PROJECT AR 10774(0)
MAJOR BRIDGE REHAB
I-90 BRIDGE REPAIR-BEAR CANYON
GALLATIN COUNTY

BRIDGE PLANS & QUANTITIES

General: The plans provided are the original and as-built drawings for this structure. The mark-ups and notes reflect the work needed to replace two damaged Type 4 prestressed beams in the center span of the bridge.

Slab Removal @ Intermediate Bents

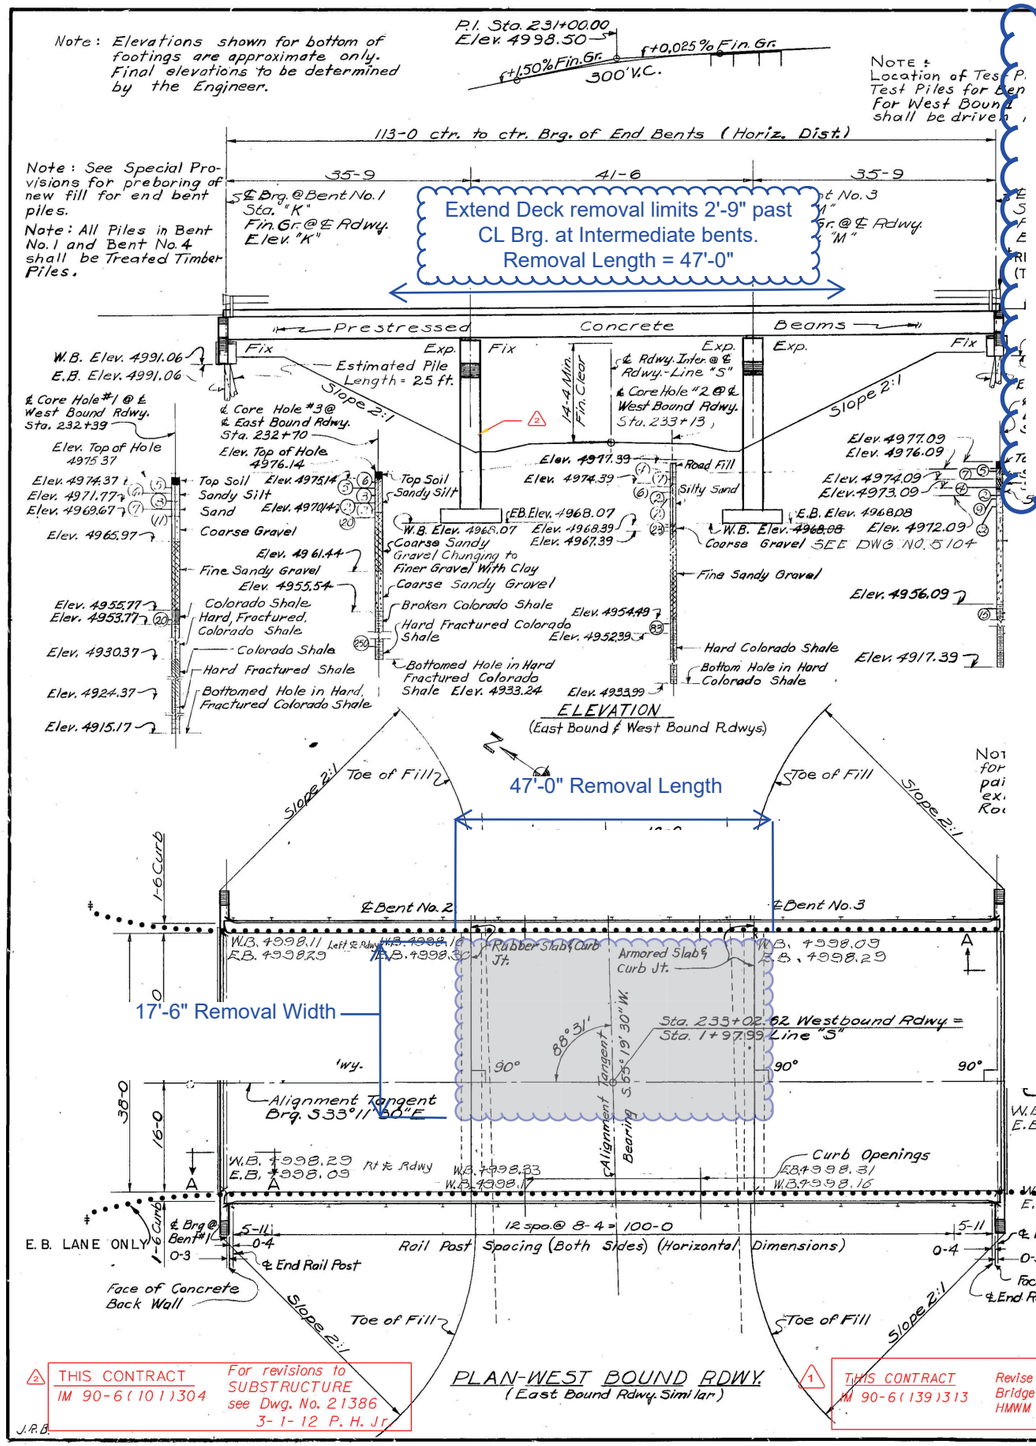
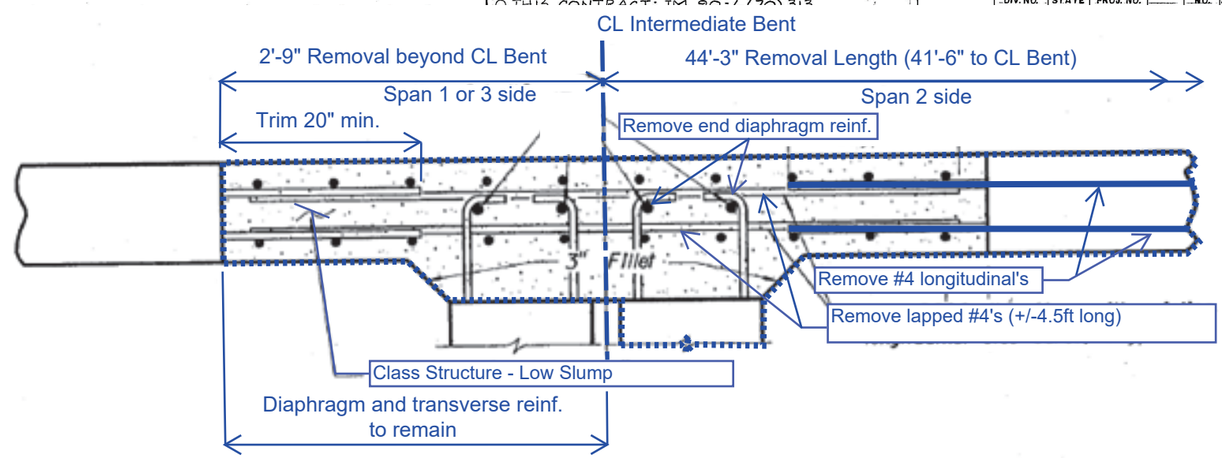
1.) Saw cut 1/2" deep around the perimeter of the Deck Removal limits (typ).
2.) Lap splice #4 longitudinal bars 20" min.
3.) Clean all existing reinforcing steel prior to pouring new concrete.
4.) Reinforcing steel that is called out to remain and is damaged during construction will be replaced at no additional cost to the state.
5.) See sheet 5 for deck removal location.

SHEAR BLOCK & CAP RETROFIT
DETAILS BENTS NO. 2 & 3

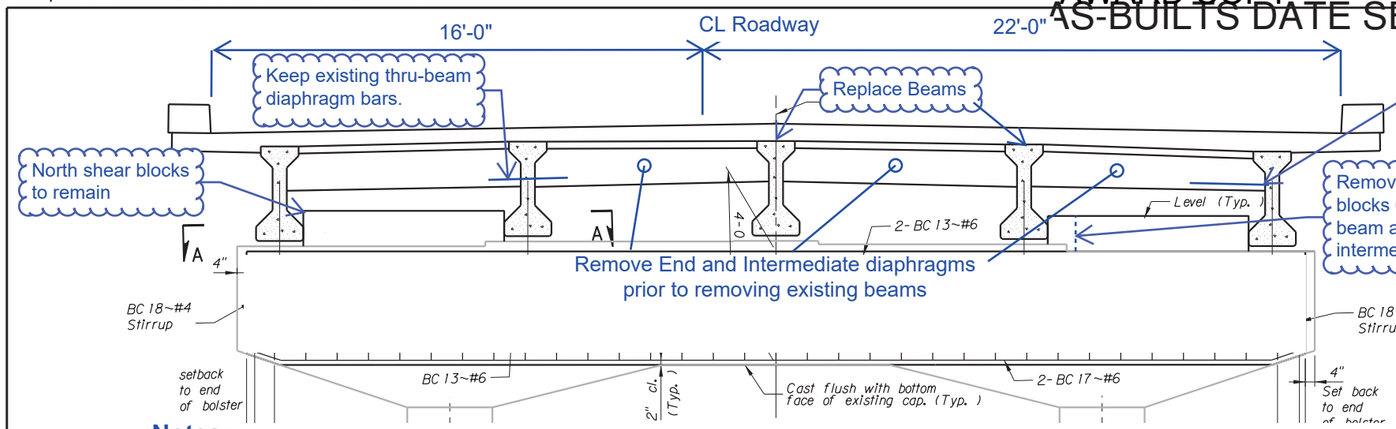
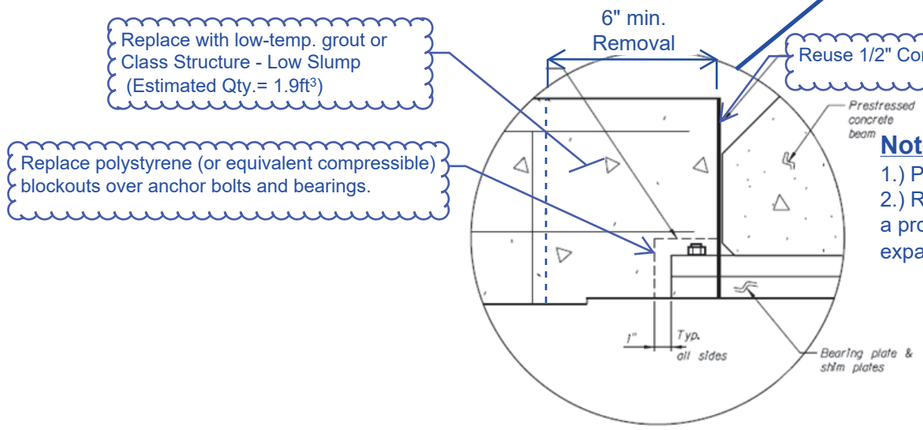
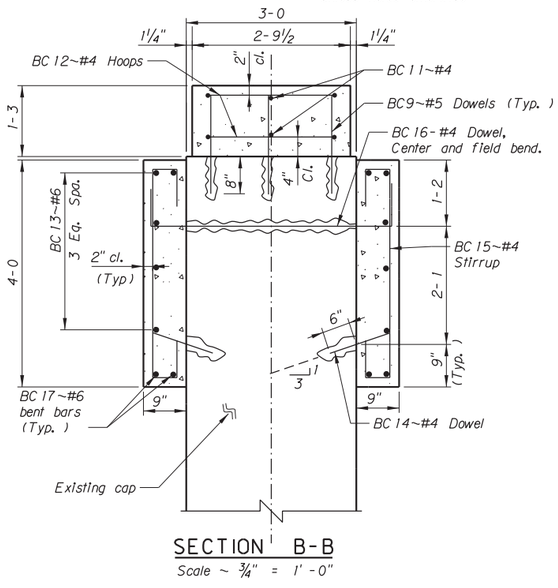
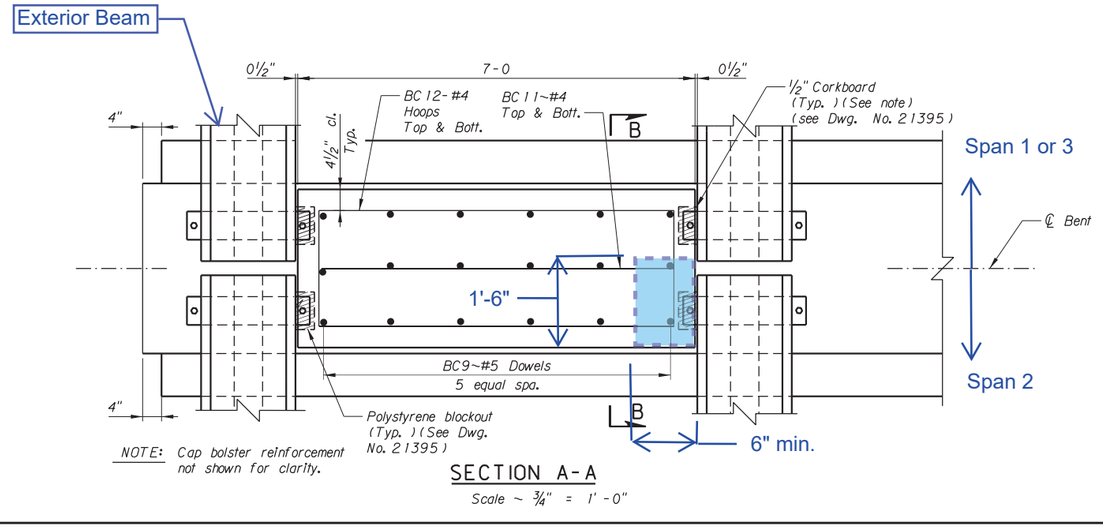
1.) Saw cut 1/2" deep around the perimeter of the shear blocks before partial removal (typ). Do not cut existing reinforcing.
2.) Clean reinf. bars before placing new concrete or grout.
3.) Recasting the shear blocks is allowed after traffic is back on the bridge.

1.) Preapproved low-temp grout: Five Star RSR Easy Mix.
2.) Replace corkboard that is damaged during shear block removal. Use a product from the Qualified Product List or an alternative preformed expansion joint filler with similar performance characteristic.

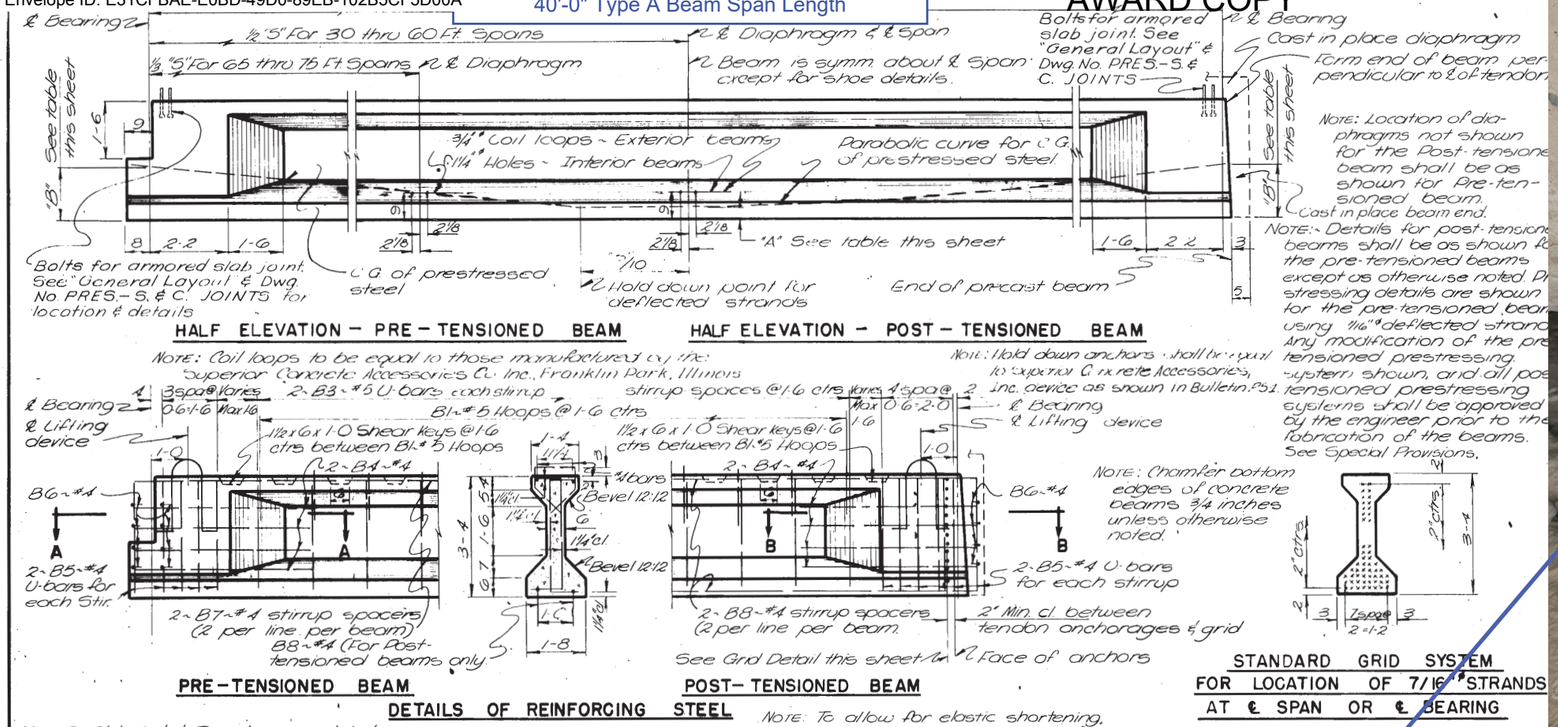
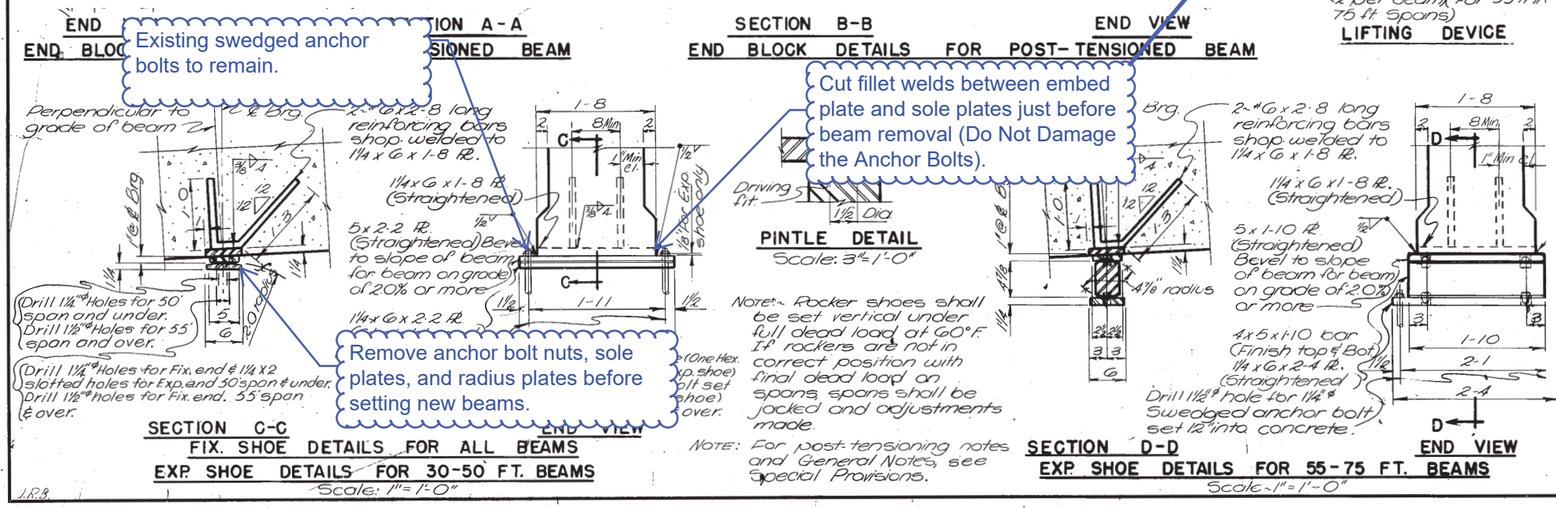
1.) Prestressed Type A beams are being state furnished. See special provision for shipping contact information.

2.) Include all cost associated with cutting beams loose from the bearings, removing anchor bolt nut, and bearing plates in the cost for Miscellaneous Items - LS.

1.) Clean anchor bolt threads above the nut using a wire brush. Remove all rust, paint, and debris.

2.) Apply a liberal amount of penetrating oil (Tri-Flow, Kroil, or CRC Freeze-Off) and allow to sit a minimum of 12hr.

3.) Attempt to loosen anchor bolt nuts using standard hand tools. Do not round off the nuts or damage threads with excessive force. If the nut is still seized move to step 4.

4.) Use oxy/acetylene set up with cutting head or brazing tip and carefully heat only the nut to be removed. Do Not Heat the Anchor Bolt. The anchor bolt must not change color from it's ambient temperature color during heating of the anchor bolts. Concentrate the flame as shown by the arrows in the picture above.

5.) Immediately after removing the nut from the flame, attempt to loosen the nut using hand tools. If the nut cools before breaking loose, apply more penetrating oil and allow to sit.

6.) It is likely that it will take several heating/cooling cycles before the nuts can be completely removed. It is critical that the anchor bolt is not heated above the temperature explained in step 4. The heating and cooling process is what breaks the bond in the threads.

7.) Once the top nut is removed, clean the anchor bolt threads per step 1 and repeat steps 2 thru 6 as necessary to remove the nut.

STANDARD SLAB, CURB & DIAPHRAGM FOR PRESTRESSED CONCRETE BEAMS
30 THRU 65 FT. SPANS-38 FT. ROADWAY
H20-S16 OR ALTERNATE LOADING
1-10 CURB & STD. STEEL BRIDGE RAIL-TYPE NO. 4
1-6 CURB & STD. STEEL BRIDGE RAIL-TYPE NO. 4
1-6 CURB & STEEL BEAM BRIDGE RAIL

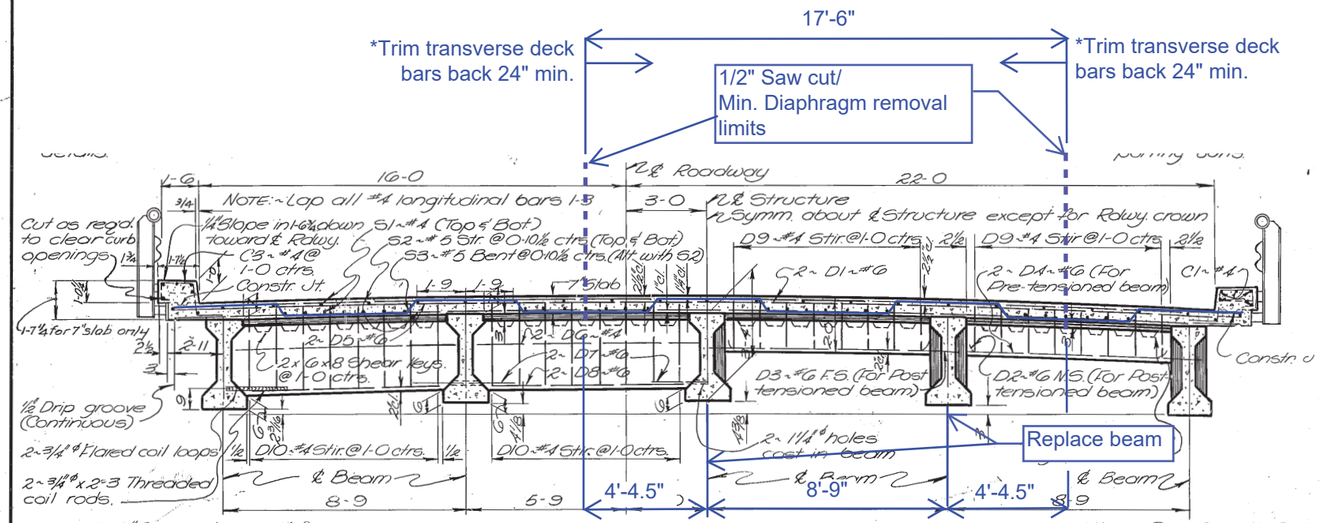
1.) Provide 30" minimum lap splice for #6 diaphragm bars (D1, D4, D5, D7, D8) and 20" minimum for #4 diaphragm bars (D6).

2.) Trim the transverse #5 straight bars (S2, top & btm. @10.5" ctrs) back from the saw cut line to provide 24" minimum lap length.
- Add #5E straight bars (17'-6") and lap with trimmed S2's.
  Assume Qty. = (47ft/10.5in ctrs)*2 (top & btm.) = 108 bars~For information only

3.) Trim the transverse #5 crank bars (S3 @10.5" ctrs, alternated w/S2's) back from the saw cut line to provide 24" minimum lap length.
- Add #5E straight bars (17'-6") and lap with trimmed S3's. At the 1/2 bay location the S3 should be in the bottom mat.
  Assume Qty. = (47ft/10.5in ctrs)*1 (btm.) = 54 bars~For information only
- Add #5E straight bars (17'-6") above the trimmed S3's to create a top mat.
  Assume Qty. = (47ft/10.5in ctrs)*1 (top) = 54 bars~For information only

4.) Add #4E bars (47ft) to the trimmed longitudinal bars (S1's) and lap 20" min.
- Assume Qty. = 15 (btm) + (17.5ft/12" ctrs) = 33 bars~For Information Only

* Use hand tools only to remove the last 24" of concrete in the lap splice lengths.
